CITY OF ALBUQUERQUE

**RE: Baylor Drive Property
2635 Baylor Dr. SE
Grading and Drainage Plan
Engineer's Stamp Date: 08/07/19
Hydrology File: M16D044**

Based upon the information provided in your submittal received 08/07/2019, the Grading & Drainage Plan is not approved for Building Permit and for action by the DRB on Site Plan for Building Permit. The following comments need to be addressed for approval of the above referenced project:

GRADING AND
DRAINAGE PLAN

SHEET #
GR-1

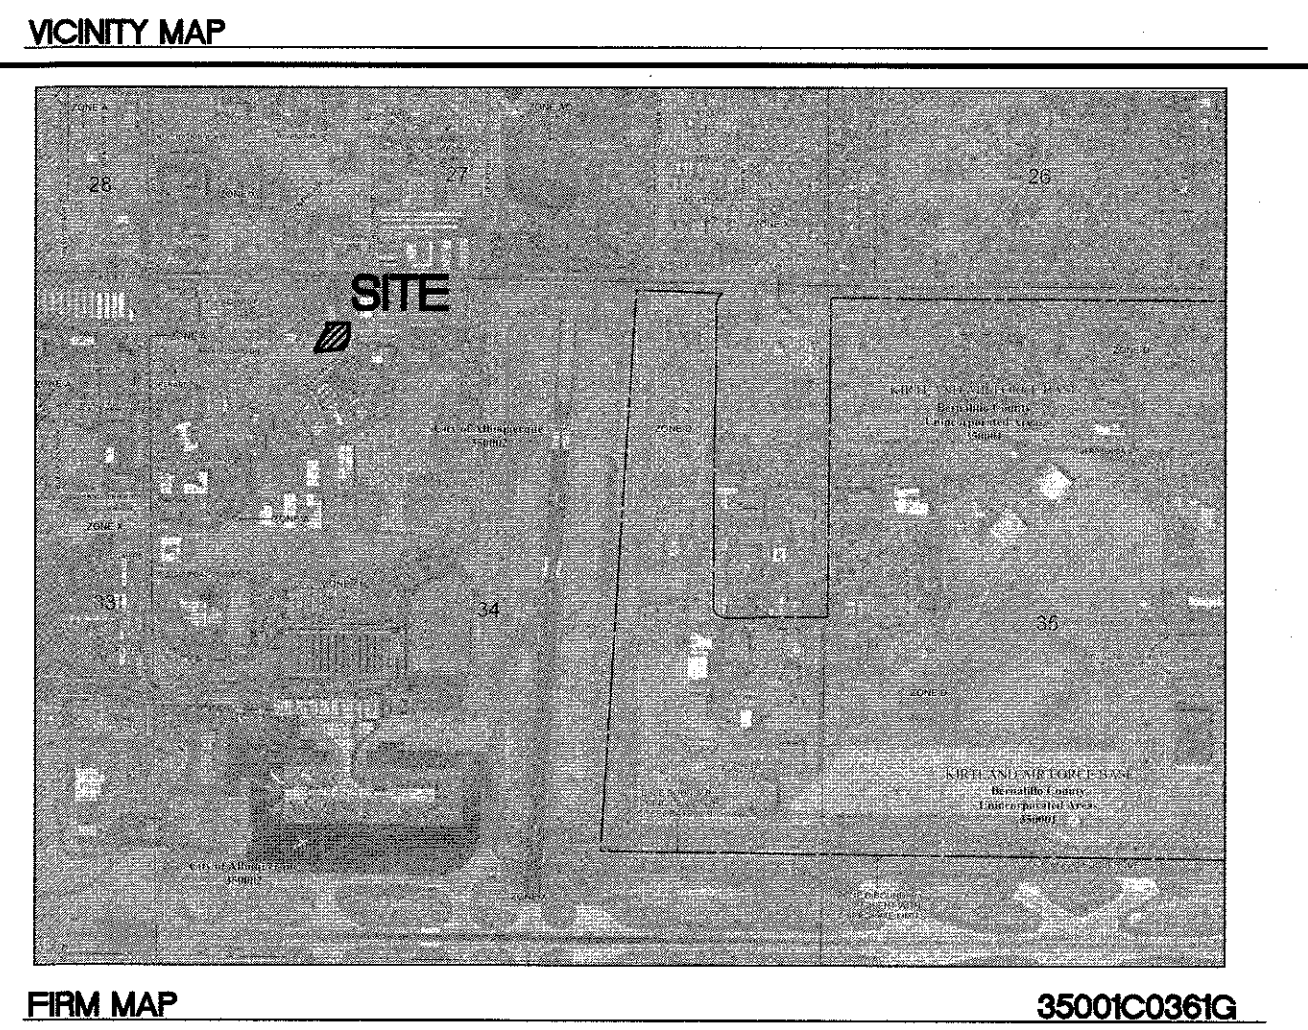
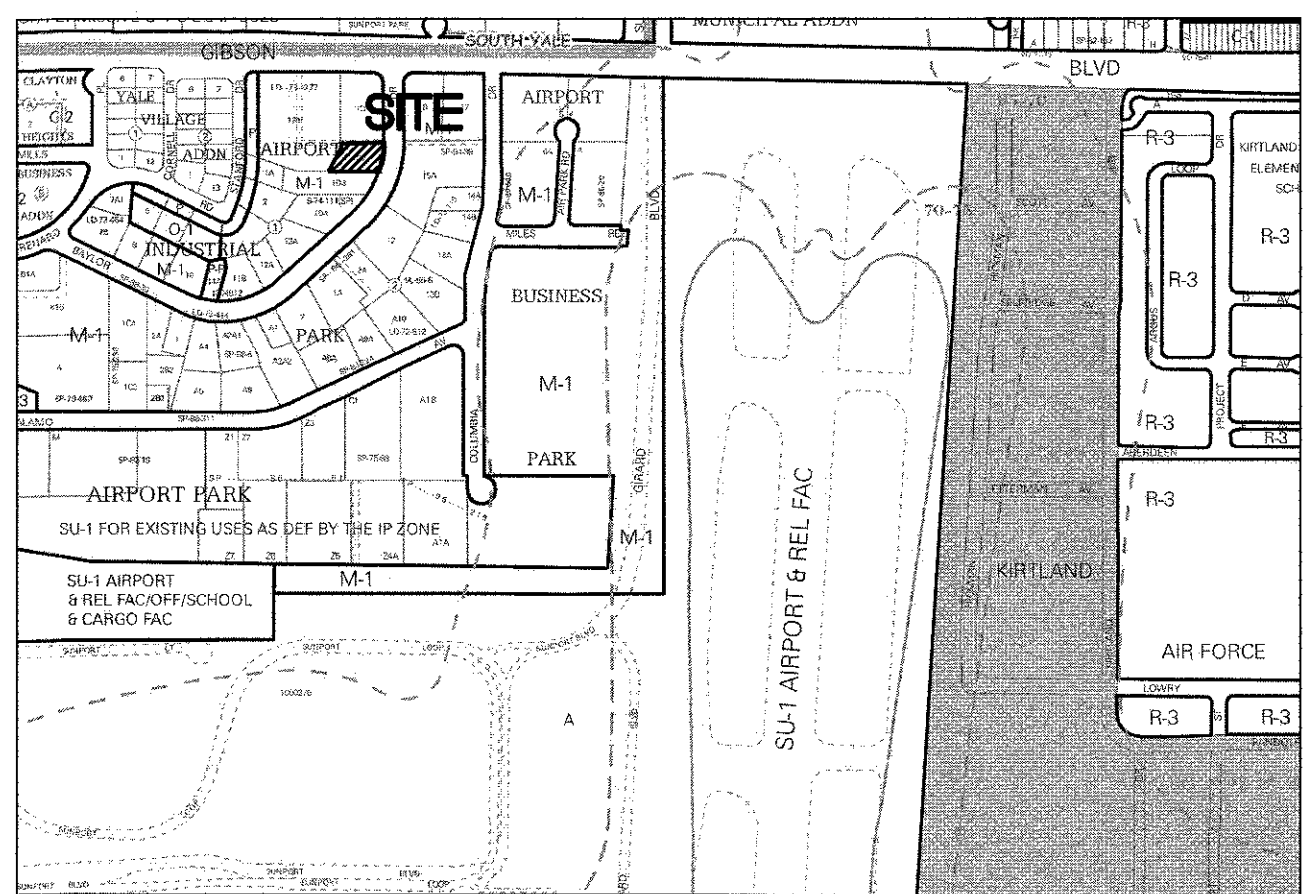
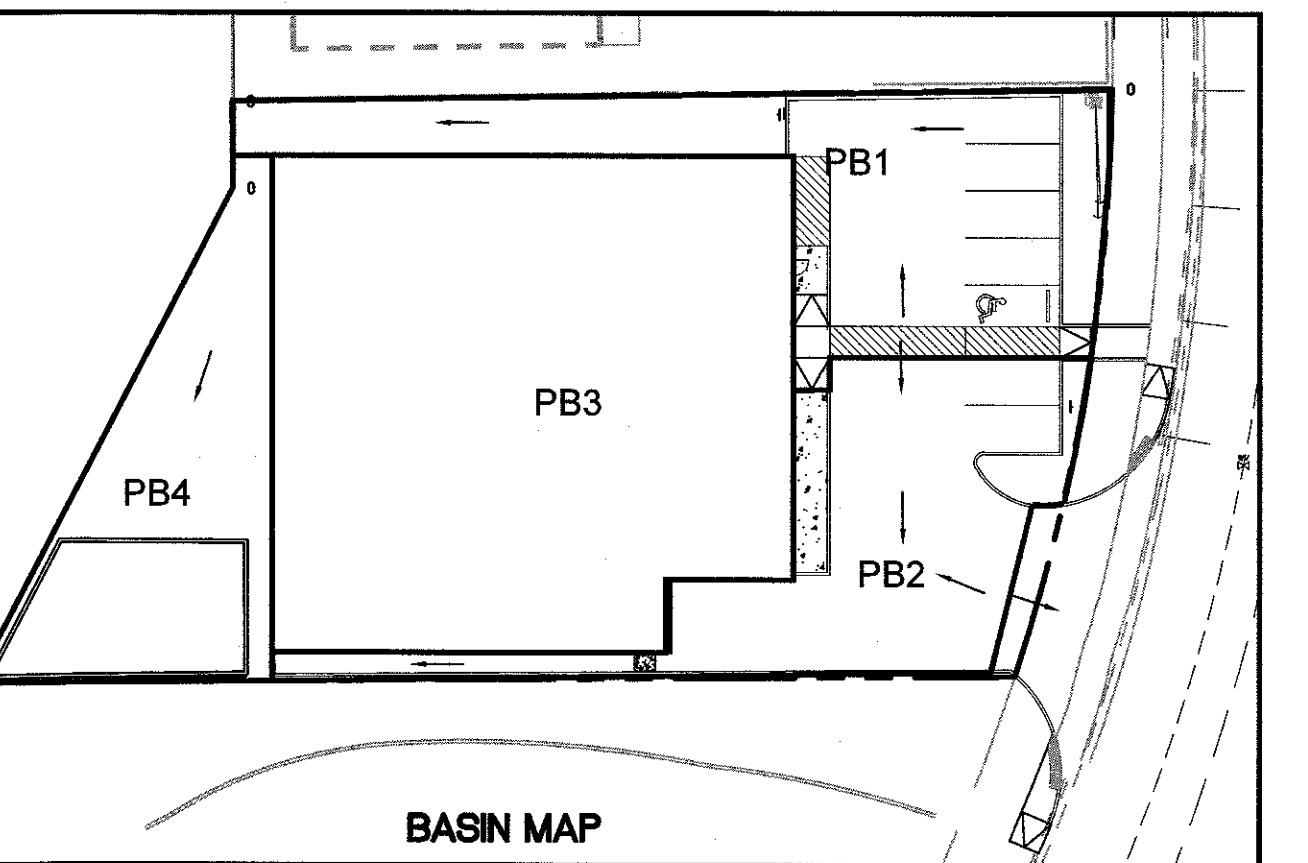
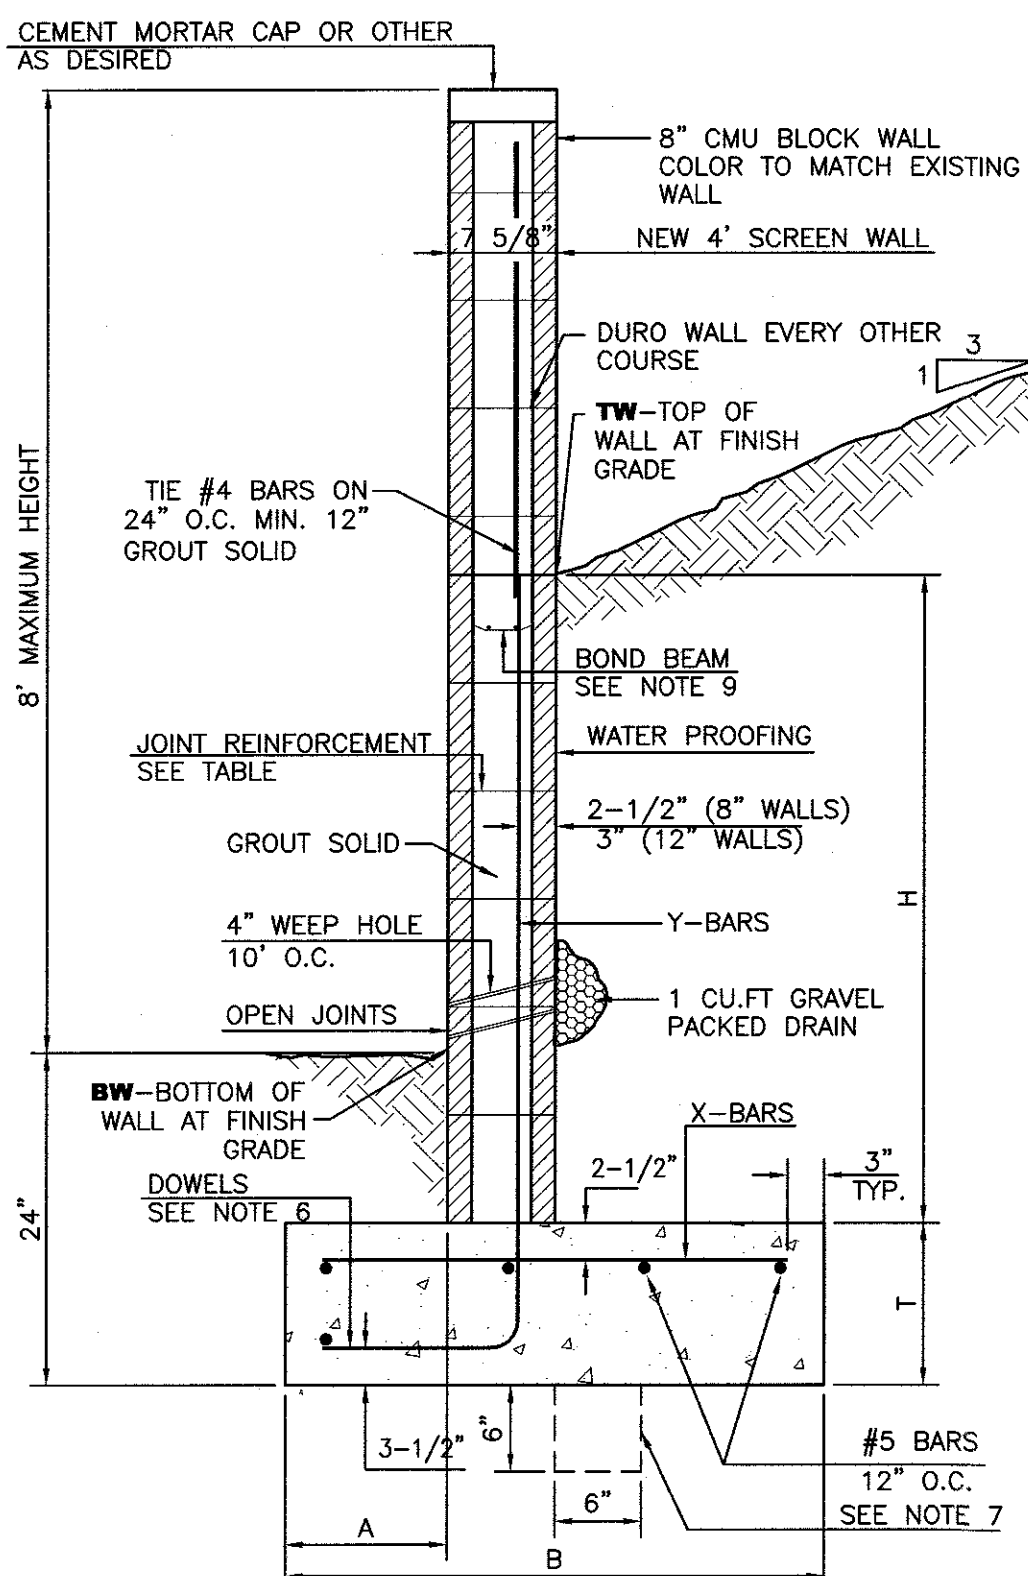
1. Provide the existing and/or proposed grades on both sides of the proposed retaining wall.
2. Provide sections through all external boundaries showing proposed retaining walls, garden walls, property/ROW lines, existing and proposed grades. In accordance with DPM Ch.22, section 5 part B, grading and wall construction near the property line may not endanger adjacent property or constrain its use.

3. If the proposed retaining wall will create such an encroachment, written agreement from both landowners must be provided for such work. Written permission must include: signature of the property owner or owners representative, statement that undersigned is the owner or authorized representative, permission to construct the encroachment with a brief description of the encroachment.

4. Please provide a cross section of the proposed retention pond showing dimensions, the bottom elevation, the top of wall, and the water surface elevation of the 100 year 10 day volume.

5. Please provide a detail of the proposed 2 ft concrete channel entering the walled retention pond.
6. Please fix several overlapping text and missed placed text.
